**SITE:** Land adjacent to Englands Gate Inn, Bodenham, Herefordshire, HR1 3HU  
**TYPE:** Outline  
**DESCRIPTION:** Residential development of up to ten dwellings with associated vehicle access  
**APPLICATION NO:** 171319  
**GRID REFERENCE:** OS 354294, 251285  
**APPLICANT:** Mrs E McNeil  
**AGENT:** Mr D F Baume  
**DATE OF THIS RESPONSE:** 5<sup>th</sup> May 2017

This response is in regard to flood risk and land drainage aspects, with information obtained from the following sources:

Figure 1: Environment Agency Flood Map for Planning (Rivers and Sea), May 2017

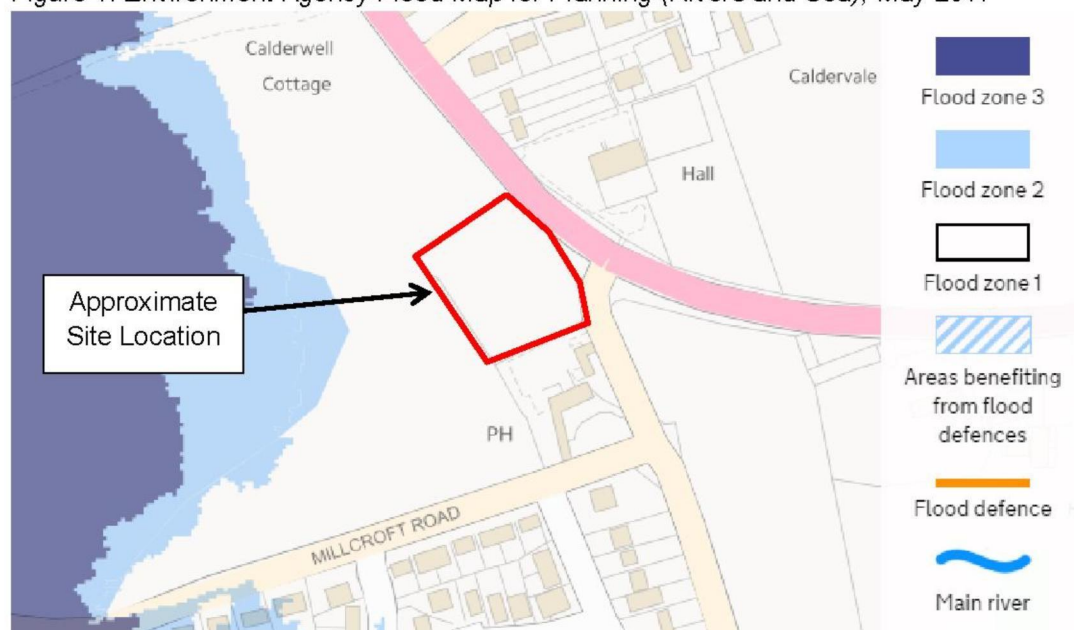
Review of the Environment Agency's Flood Map for Planning (Figure 1) indicates that the site is located within the low risk Flood Zone 1: Flood Zone 1 comprises land assessed as having less than a 1 in 1,000 annual probability of river flooding.
